August 2017 | Final Environmental Impact Report  
State Clearinghouse No. 2015101075

# SOUTHEAST AREA SPECIFIC PLAN

City of Long Beach

Figure 3-2 - Local Vicinity  
3. Project Description

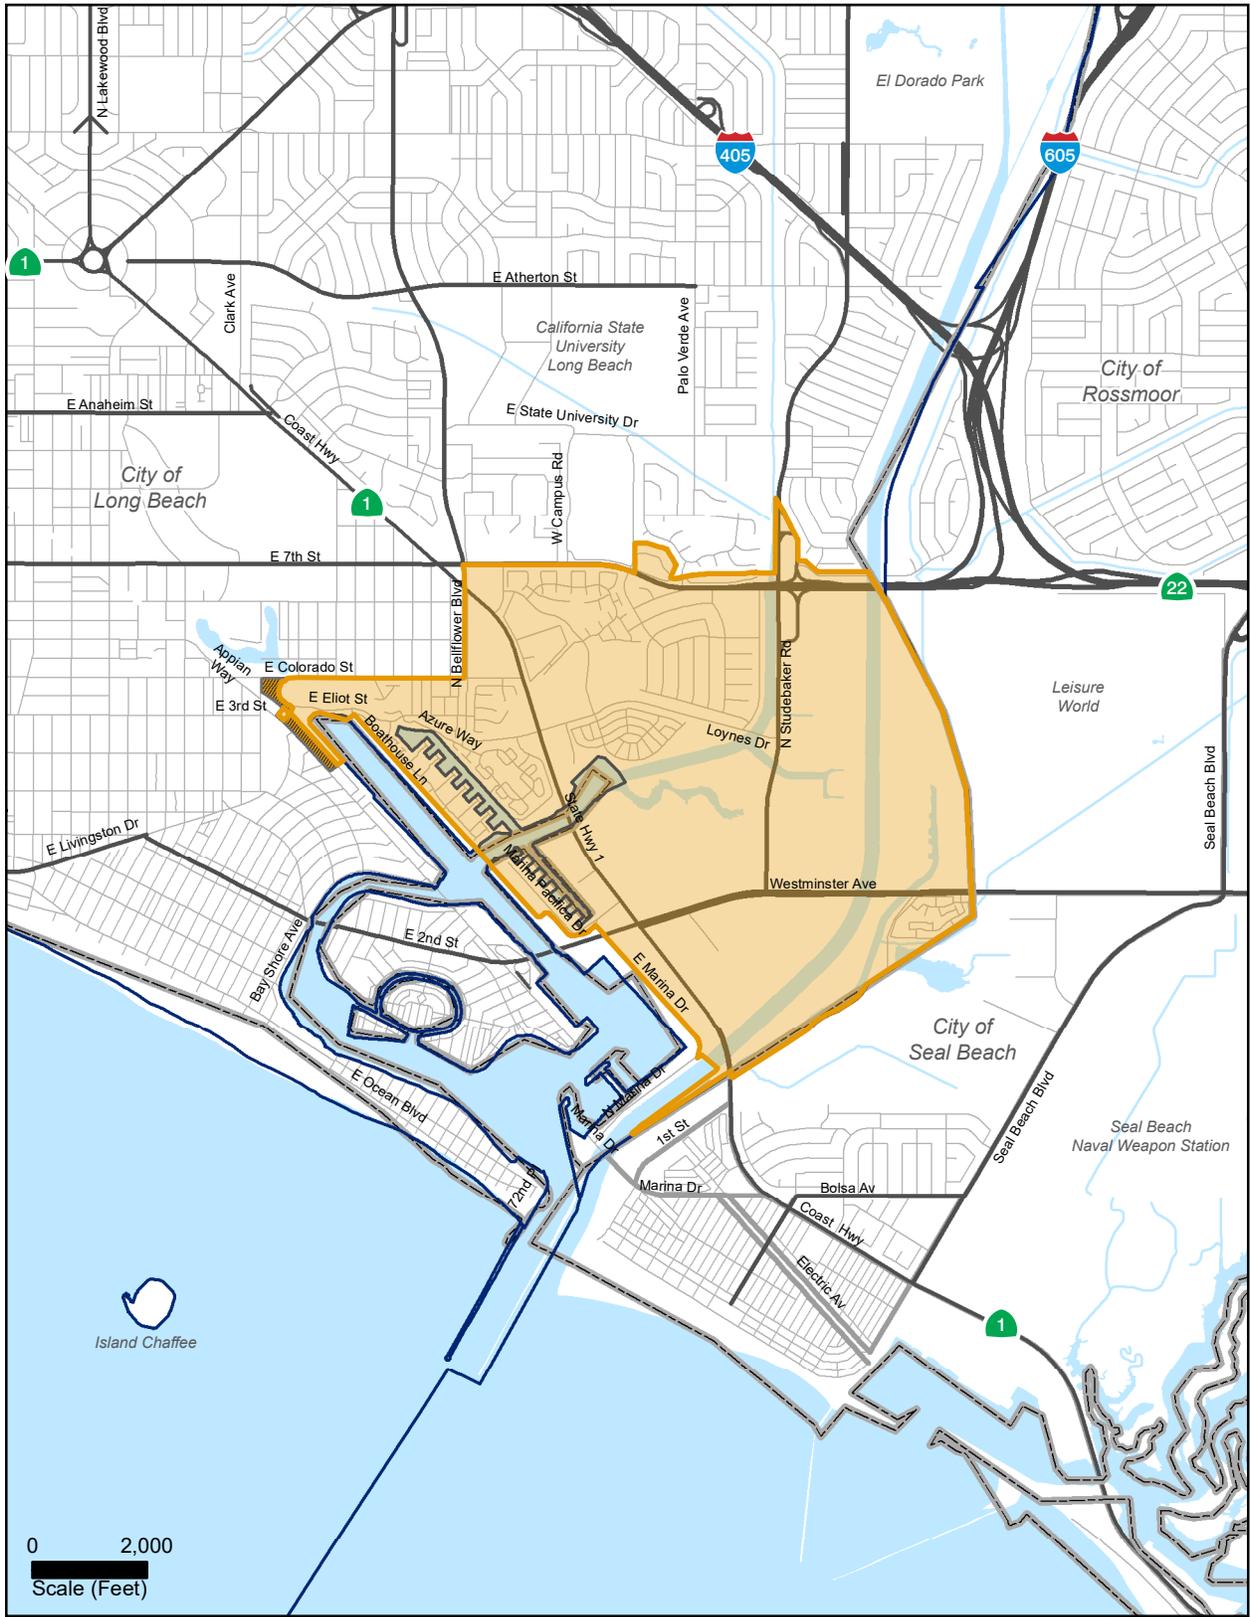
A9-1 The commenter is correct regarding the mislabeling identified on Figure 3-2 of the DEIR. This figure has been revised (see Section 5 of this FEIR).

Figure 3-2, Page 3-5, Section 3, *Project Description*, has been revised in Response to Comment A9-1 from Naval Weapons Station, Seal Beach.

Figure 3-2 has been revised to indicate the location of Leisure World in the City of Seal Beach where a label previously identified “Seal Beach Naval Weapon Station.”

Figure 5.4-4 - Wetlands  
5. Environmental Analysis

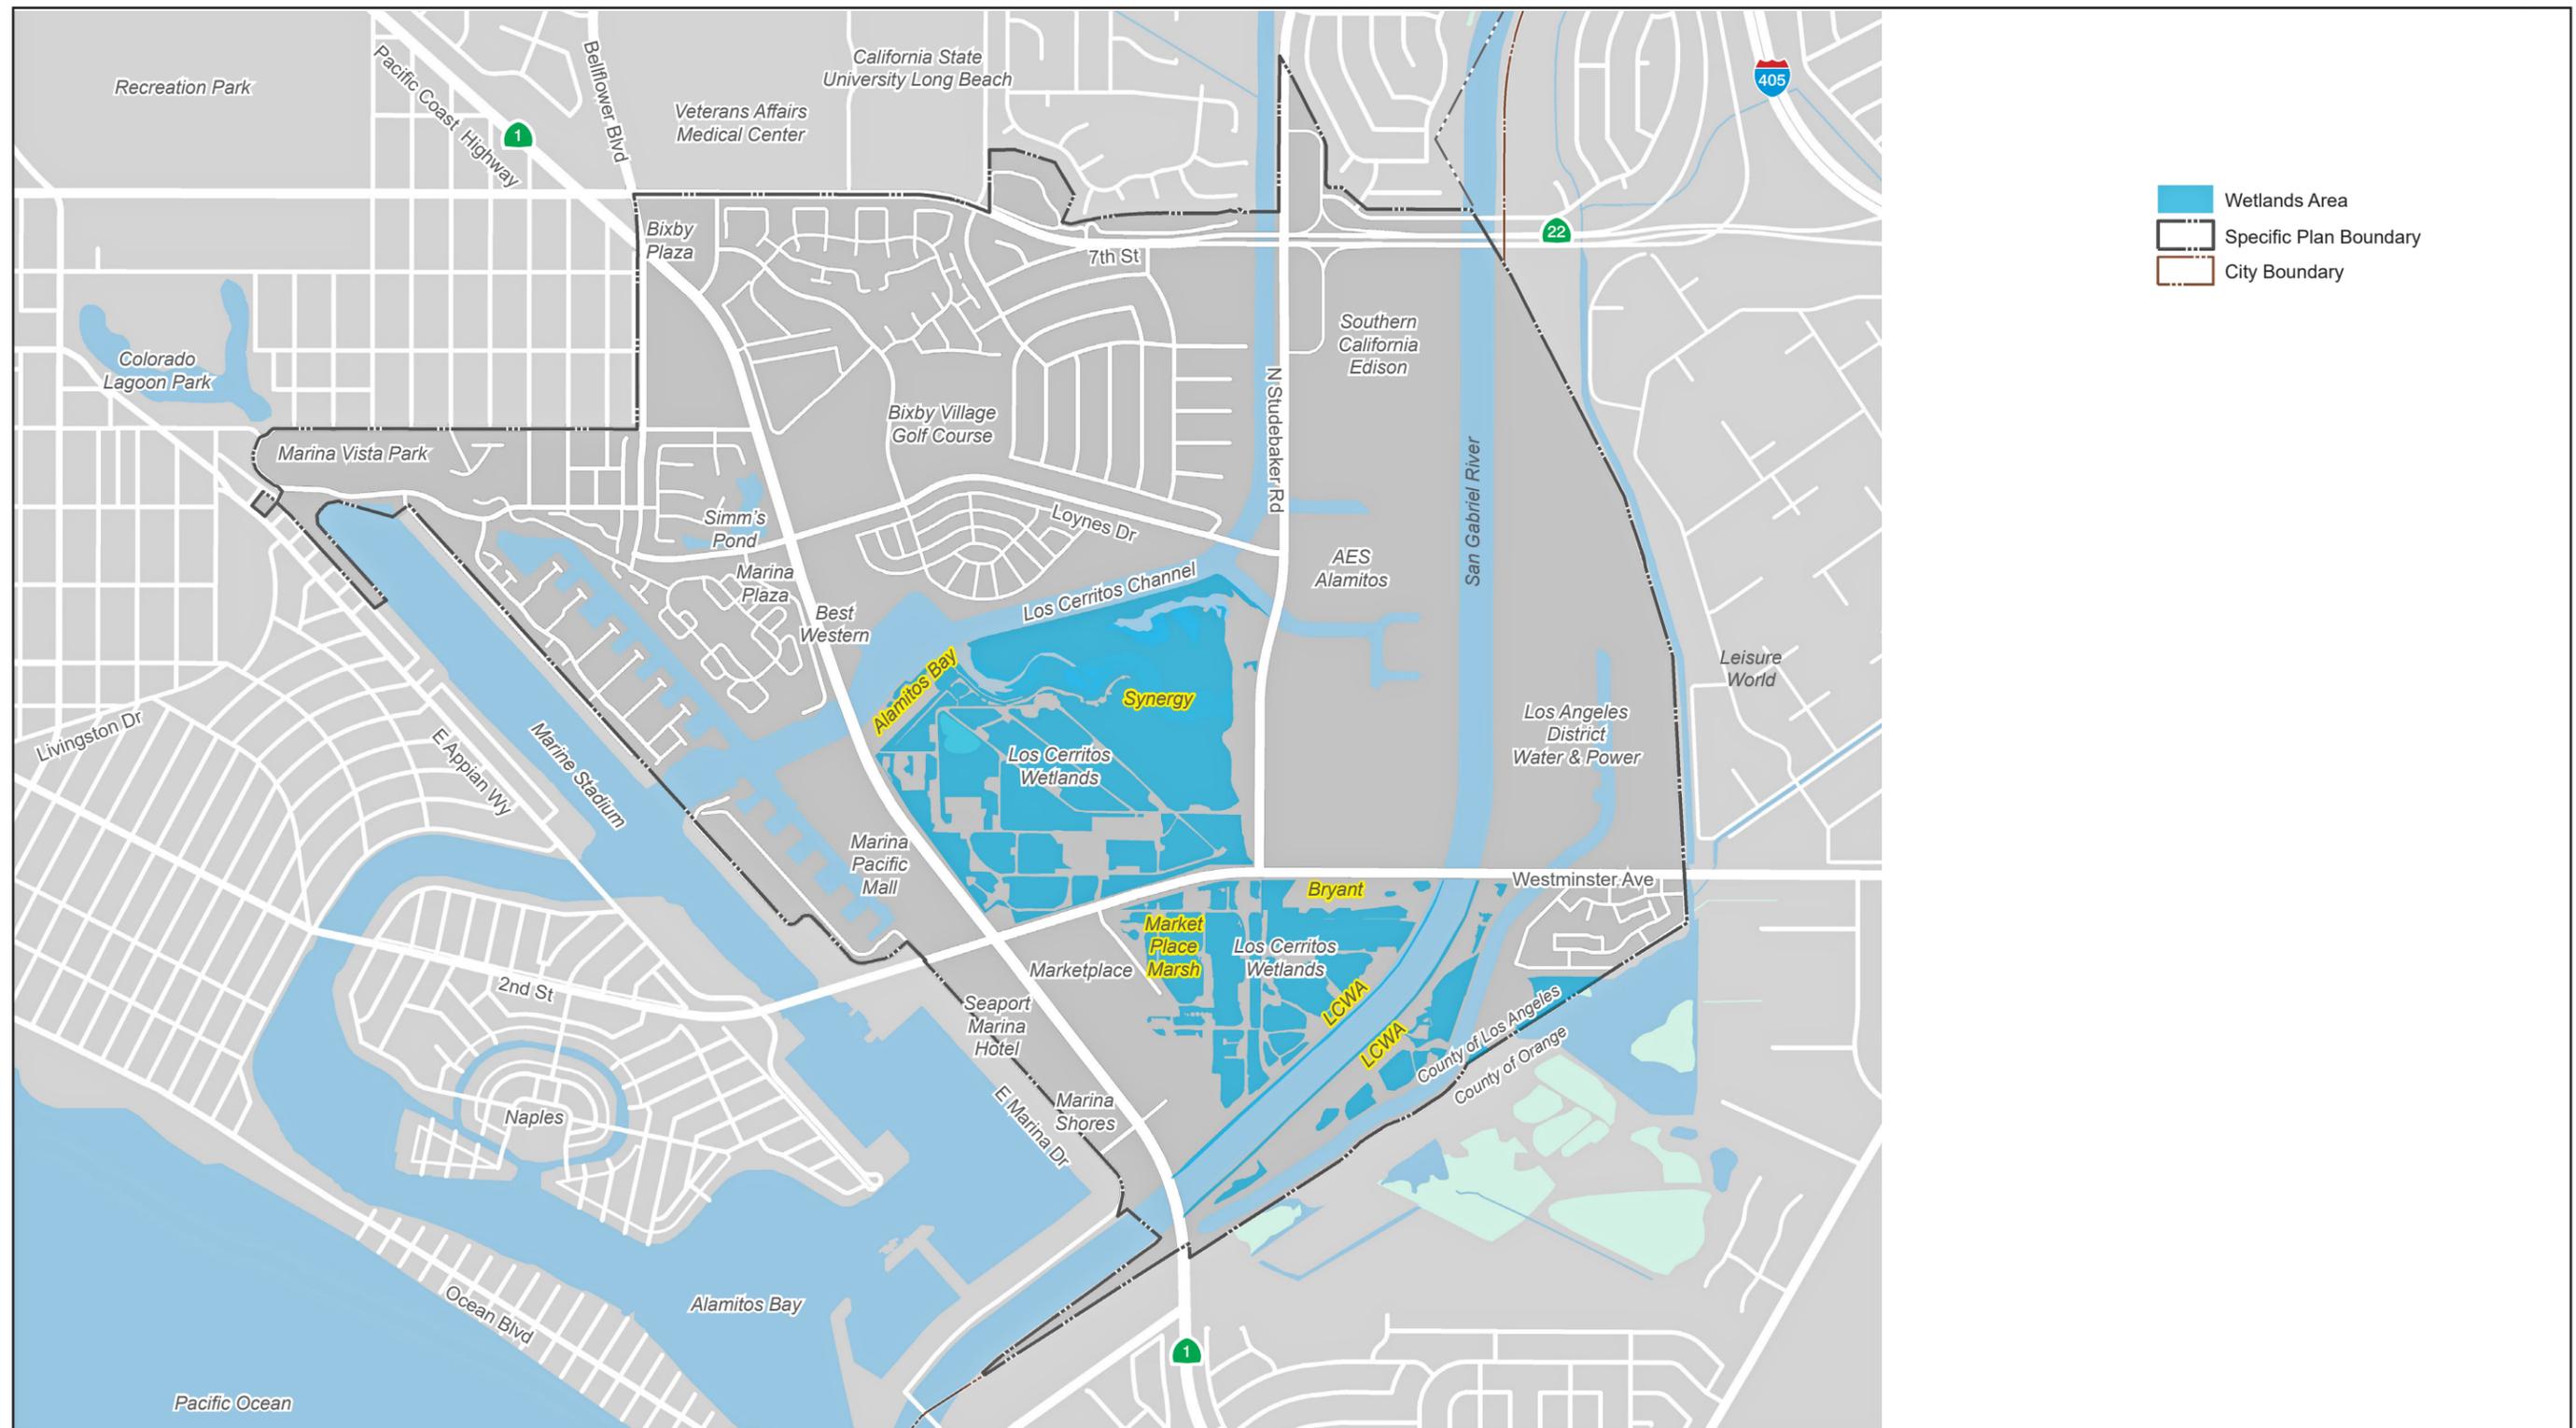
- A7-69 Figures 5.4-4 and 5.4-5 of the EIR has been revised to label the delineation areas (see Section 5 of this FEIR).
- A7-70 Page 33 of SEASP identifies the area referred to by the commenter as a retaining basin owned by the Orange County Flood Control District, also described as the Los Alamitos Retarding Basin. A pump station in the basin pumps stormwater into the San Gabriel River. When the pump station cannot keep up with the inflow, excess water is stored in this basin until it can be discharged. The City acknowledges that a new pump station will be constructed southwesterly of the existing pump station at the Los Alamitos Retarding Basin. The Project will nearly double the capacity of the existing pump station. The Project, which is independent of SEASP, consists of a new containment structure, intake structure, control room, new pumps and natural gas engines, new control panels, back-up fuel support systems and other equipment. No change to the text is necessary.

Figures 5.4-4 and 5.4-5, Pages 5.4-21 and 5.4-22, respectively have been revised in Response to Comment A7-69 from Los Cerritos Wetlands Land Trust.

Figures 5.4-4 and 5.4-5 have been revised to include labels of the wetland delineations referenced in the text.

Figure 5.17-2 - Proposed Sewer Demands  
5. Environmental Analysis

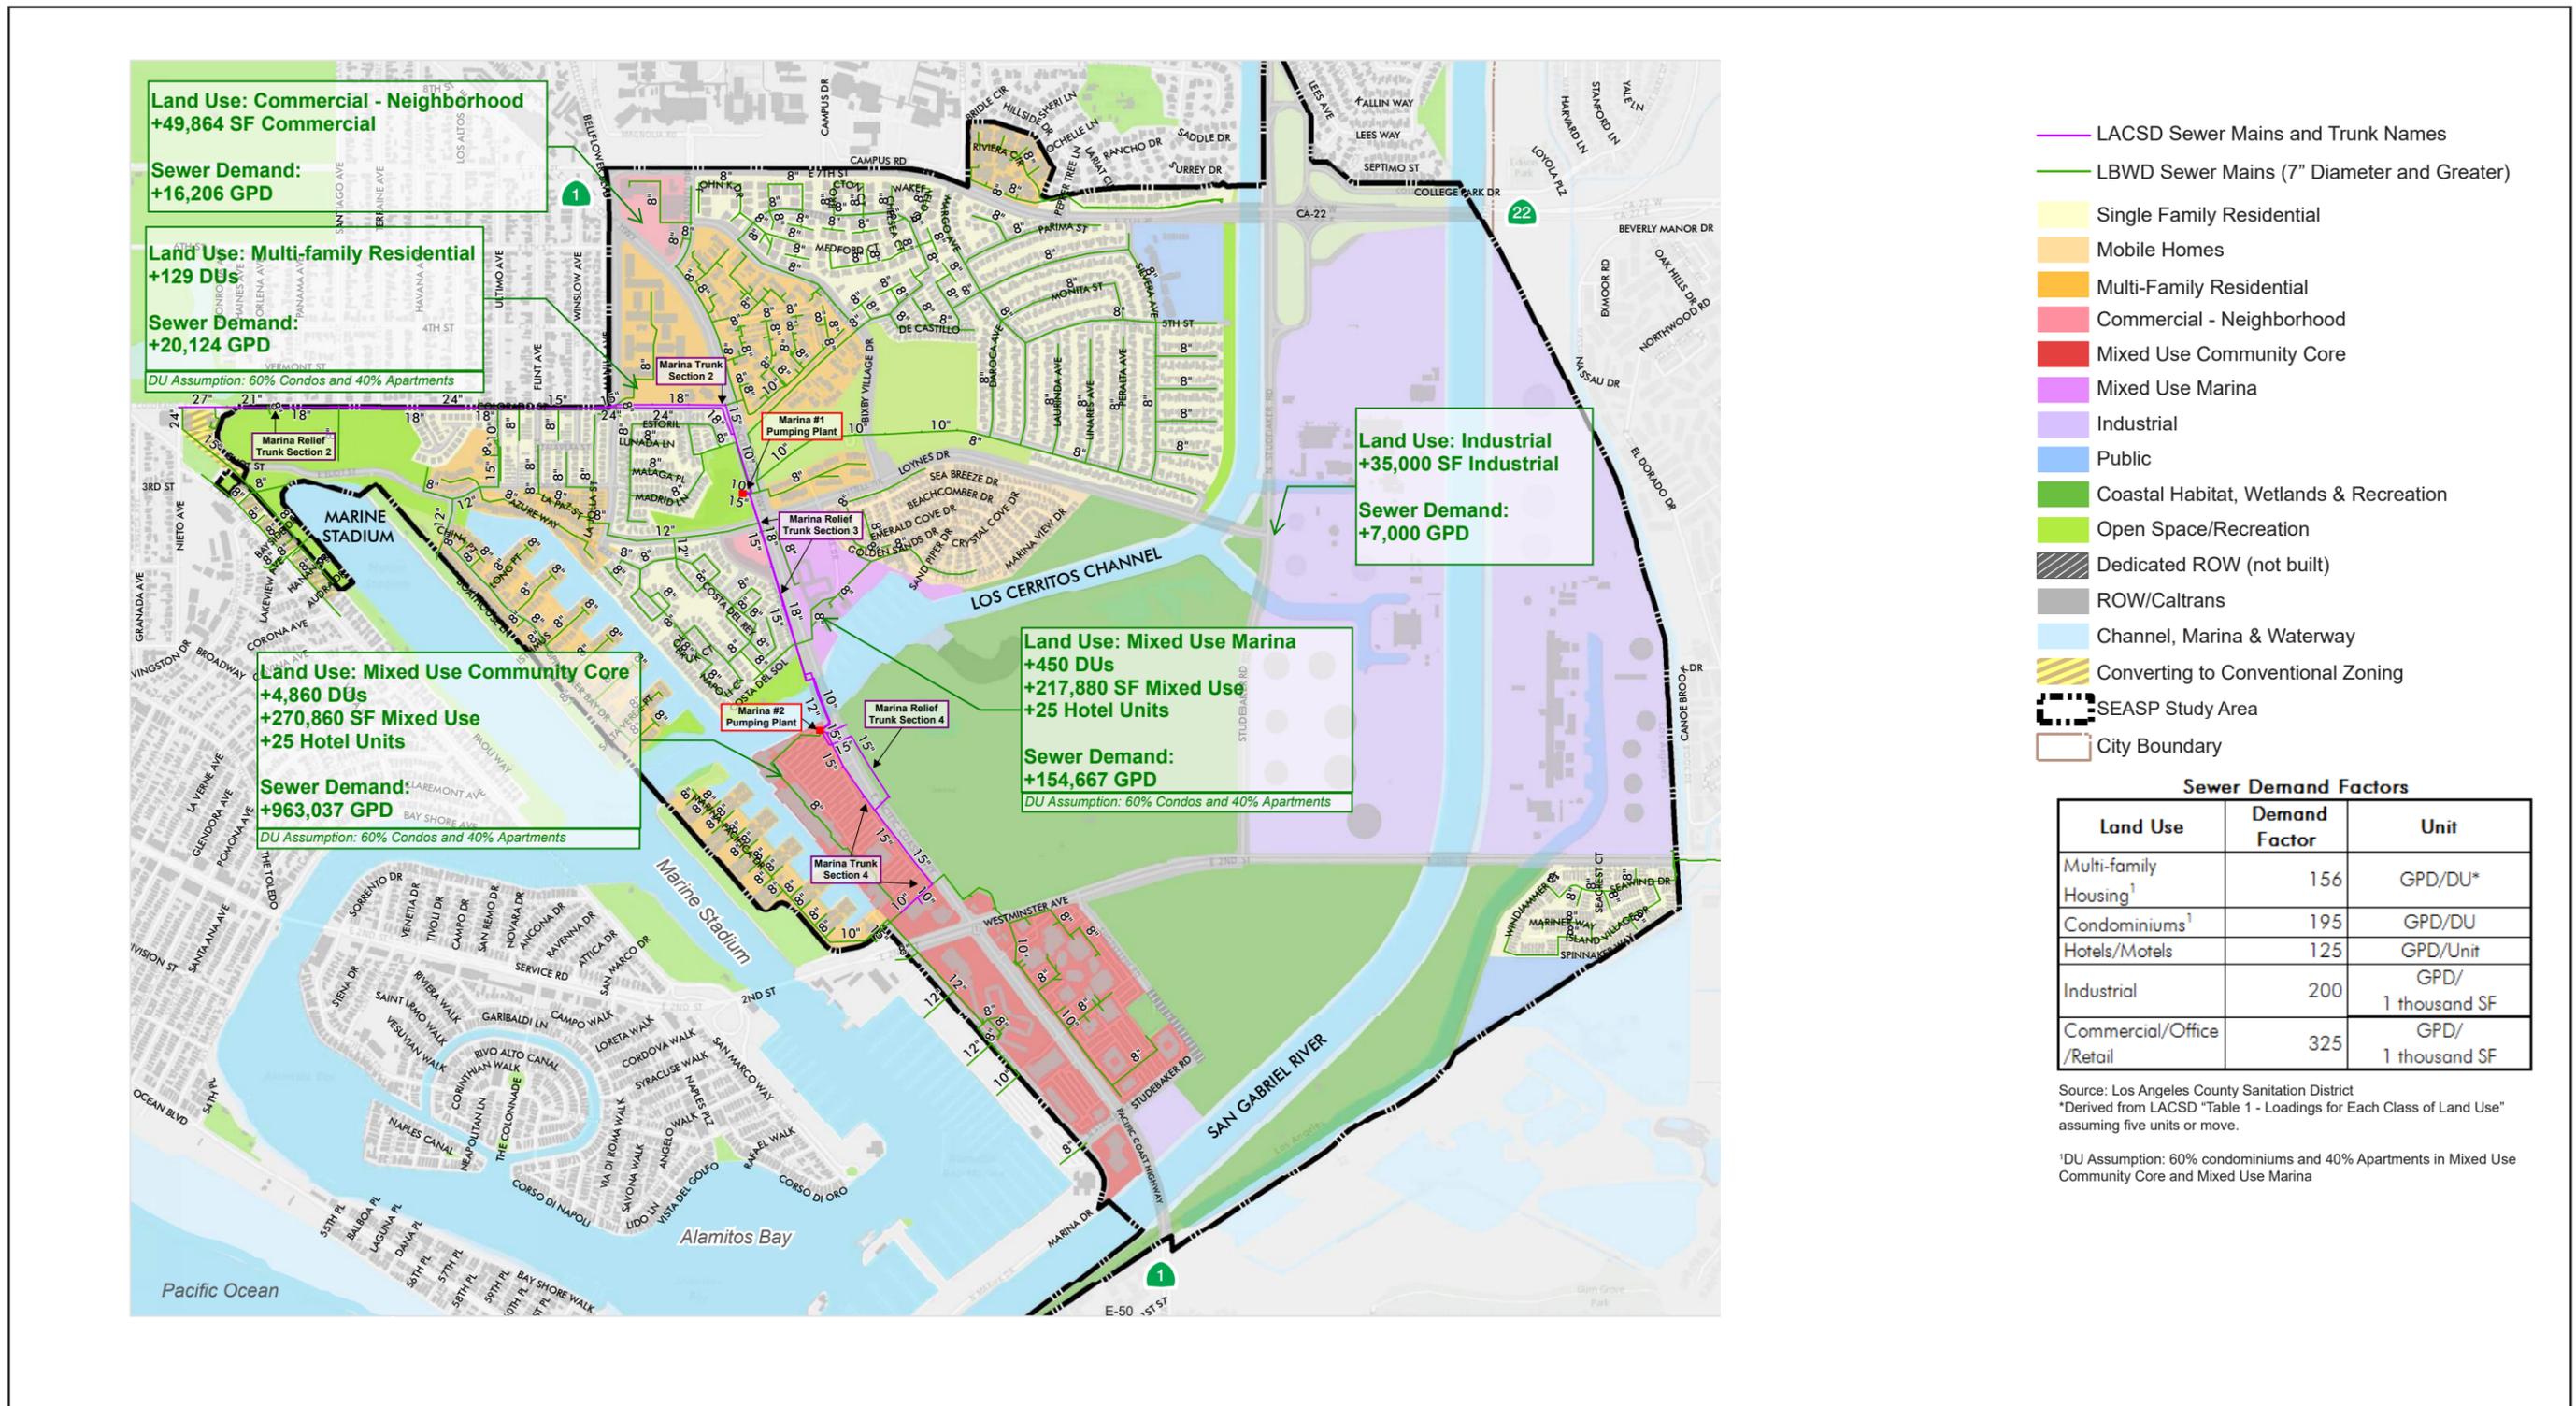
A12-4 Figure 5.17-2 in the DEIR has been revised.

Figure 5.17-2 on Page 5.17-9, Section 5.17, *Utilities and Service Systems*, is hereby modified as follows in Response to Comment A12-4 from Sanitation Districts of Los Angeles County.

Notation on Figure 5.17-2 was corrected to show a larger projected sewer demand for the Multi-family Residential land use designation (23,127 GPD instead of 20,134 GPD).
